Water Resources Department

FORWARD TO: DATE: SATE
FROM: WATERMASTER, DISTRICT # GROUNDWATER SECTION
(SIGNATURE) Will date signed 4/4/07 signed by injury reviewer
SUBJECT: WATER RIGHT TRANSFER # 10268
A change in: POU POD POA USE of water. In the name(s) of Say ose Sand & Gravel
In my opinion (assuming the right is valid), the proposed change
MAY BE MADE WITHOUT INJURY WOULD RESULT IN INJURY* to an existing water right.
*The approval of this transfer application would result in injury to other water rights because
The existing right may not be valid because
Headgate notices <u>HAVE</u> <u>HAVE NOT</u> Been issued for diversion from the source(s)which serve(s) this right.
If for change in point of diversion, is there any intervening point(s) for diversion between the authorized and proposed points of diversion? (Yes or No)
In my opinion, the order approving the subject transfer application should include the following in regard to the appropriator installing suitable measuring devices in the diversion works:

File T-10268, Scappoose Sand & Gravel

Transfer Comments

Transient Stream Depletion (Jenkins, 1970; Hunt, 1999, 2003)

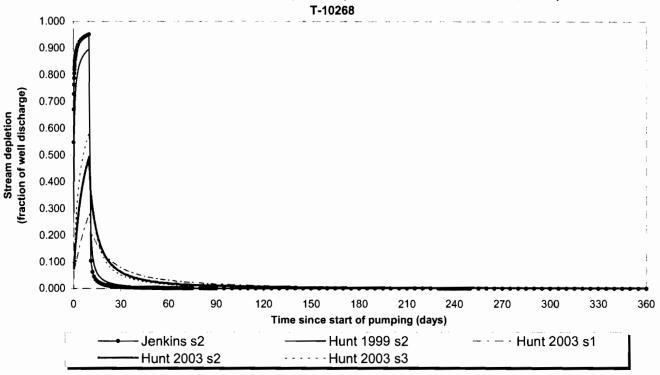
The proposed transfer will meets the "similarly" test of OAR 690-380-2130. The proposed new well will affect the surface water similarly to the authorized point of diversion. By law, similarly means a stream depletion of at least 50 percent of the rate of appropriation within 10 days of continuous well pumping. The attached calculations show that result.

The affect of the additional well on the stream is very close to 50% after 10 days. Changing parameters much quickly moves from that threshold level. Additional field testing might provide a different conclusion. The current conclusion of 50% is reasonable based on parameters that are found in USGS WSP 2470-A and on local well logs.
